DATE: 02.10.2016

■ **RENAISSANCE II BUILDING [TRC Plan Review]**

↻ Initial Review Note ↻

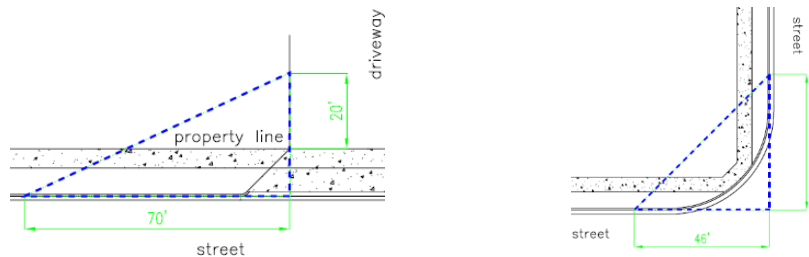
1. The right turn lane for Fresco Drive does not appear to have adequate taper and storage. Please contact Traffic Engineering to discuss possible improvements to this turn lane.
2. The proposed Roundabout appears to have a truck apron that is too small. The Roundabout must be capable of WB50 Truck Traffic.
3. Provide an Autoturns Truck Movement for WB50 and Fire Engineer Traffic at the Roundabout.
4. The radius of the proposed Roundabout does not match the radius of the existing Roundabout. Please provide dimensions of the existing and proposed Roundabouts.
5. Show a cross-section detail showing the existing street and the proposed widening.
6. Install wheelchair ramps at the two cross walks that extend from Building II to the Courtyard Building and to the Future Renaissance III building.
7. Provide tactile mats at the corners of the sidewalk along Ashes Drive and Fresco Drive.
